ADDENDUM TO
"SPECIFICATIONS FOR
BYRNES CENTER
ROOF REPLACEMENT AND REMEDIAL REPAIRS
UNIVERSITY OF SOUTH CAROLINA
COLUMBIA, SOUTH CAROLINA
PROJECT NO. H27-6094-D"

ADDENDUM NO. 1

AUGUST 28, 2012

Subject: Roof Replacement and Remedial Repairs Project
 Byrnes Center
 University of South Carolina
 Project No. H27-6094-D

SHEET
R100

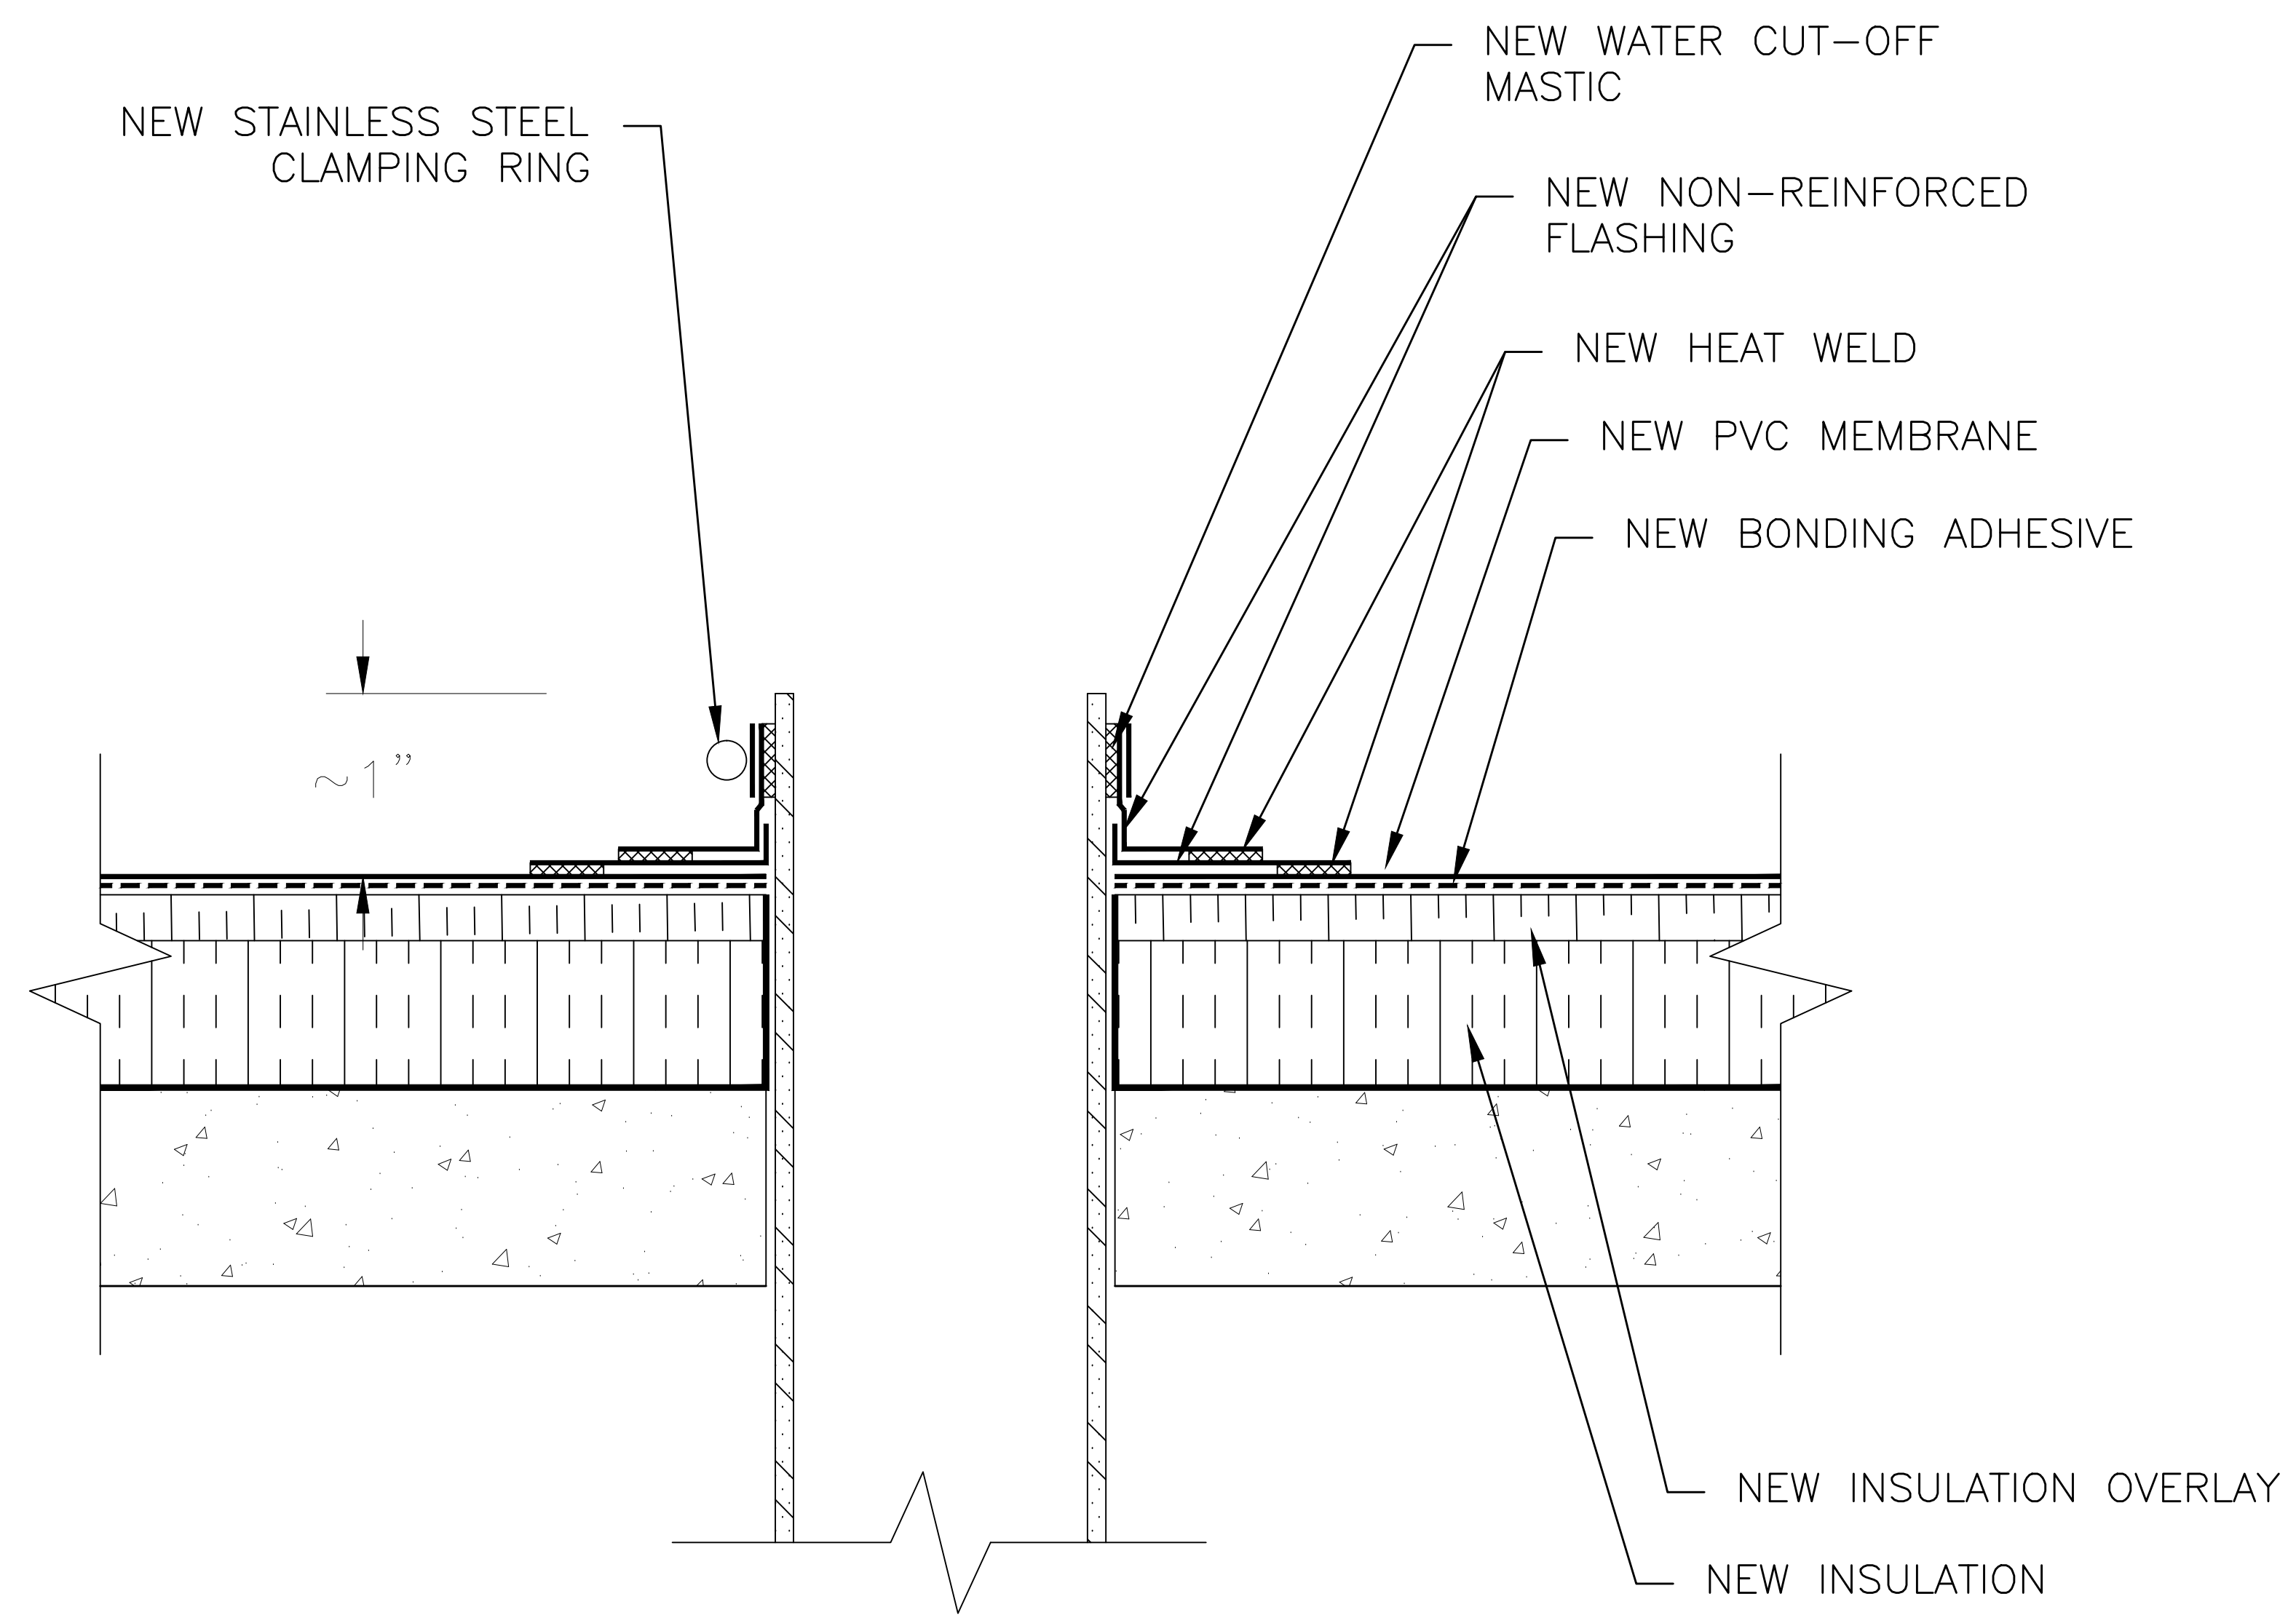
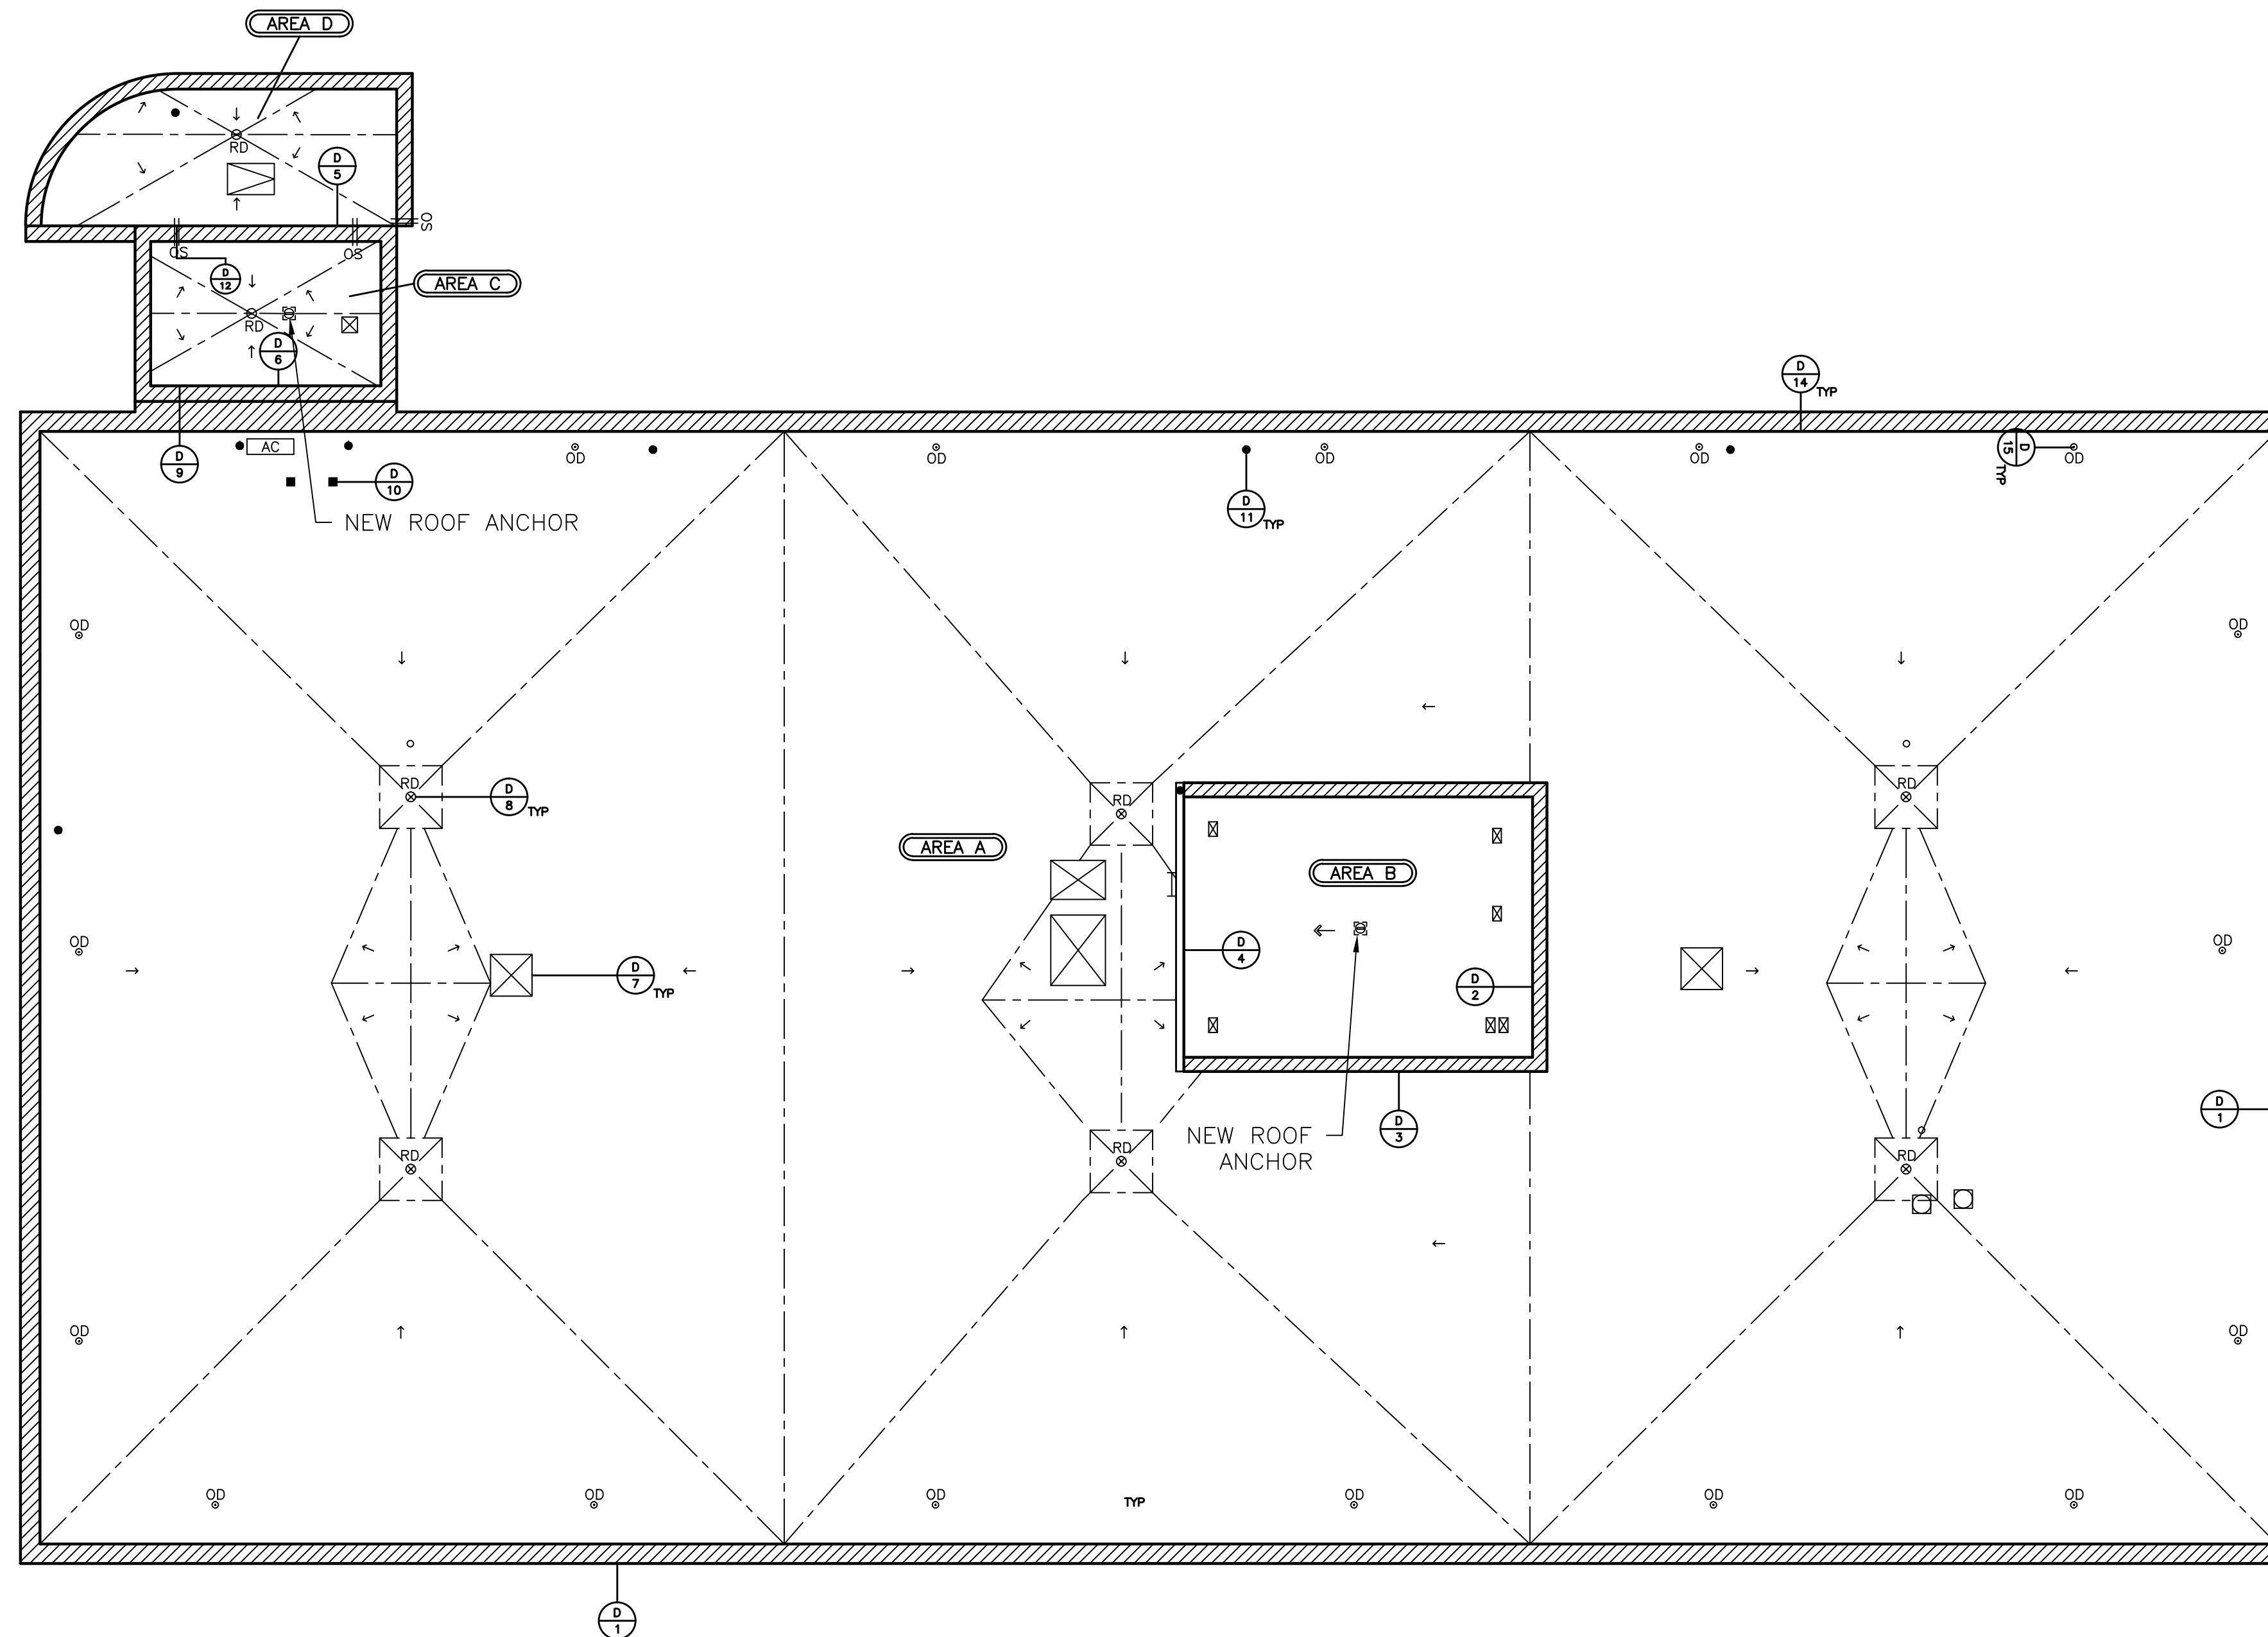
14. Delete Sheet R100 and replace with the revised Sheet R100 (Addendum No. 1).
 - Roof Plan has been revised to show existing Overflow Drains on Roof Area A and an existing overflow scupper on Roof Area D.
15. Reference Detail D1, Detail D2, Detail D3, Detail D5, Detail D6, Detail D7, Detail D9, and Detail D12; new ½ inch thick plywood sheathing is to be installed at all locations where existing base flashing has been removed and new single ply base flashings are to be installed.
16. Delete Detail D13 in its entirety.
17. Replace the Roof Safety Anchor details on Sheet R203 with the enclosed Roof Safety Anchor details.

12. Reference Paragraph 2.2 D, remove prefinished aluminum and replace with galvanized steel.
13. Reference Paragraph 3.5, delete subparagraph A in its entirety and replace with the following:
 - A. Install new scupper liners at existing overflow locations as specified herein. Refer to SMACNA Architectural Sheet Metal Manual Figure 1-26A. Refer to Drawings Sheet R100 for locations.

D15 OVERFLOW DRAIN DETAIL - ADDENDUM NO. 1
 (SCALE 3" = 1')

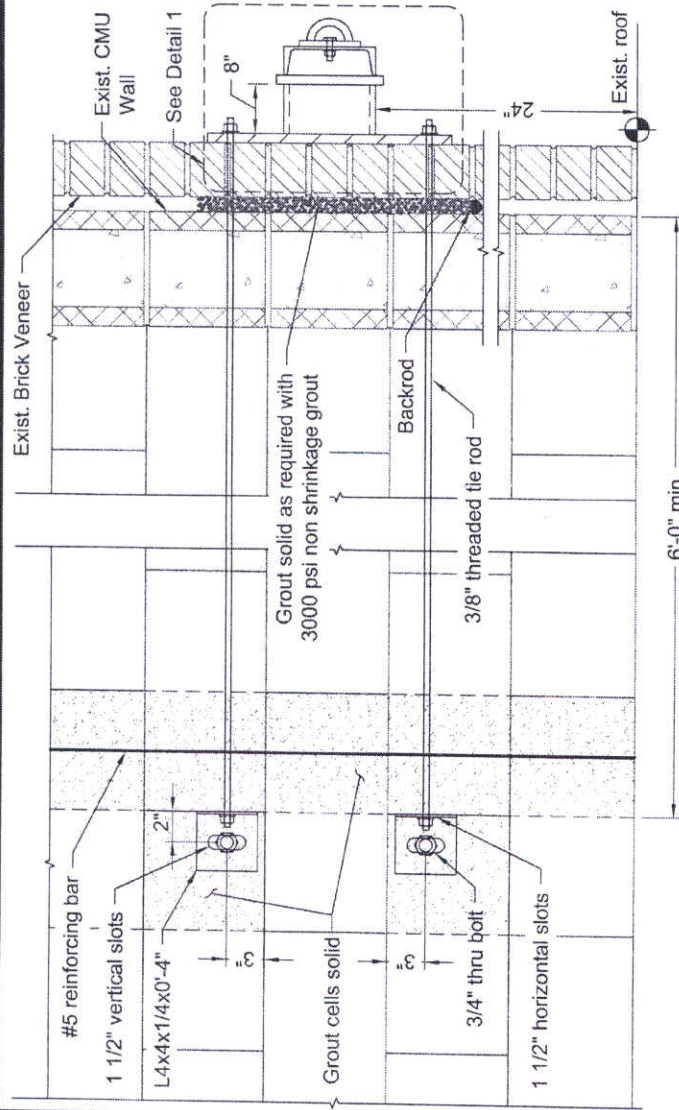
- B. Flash overflow drains as detailed in Detail D15 (Addendum No. 1).
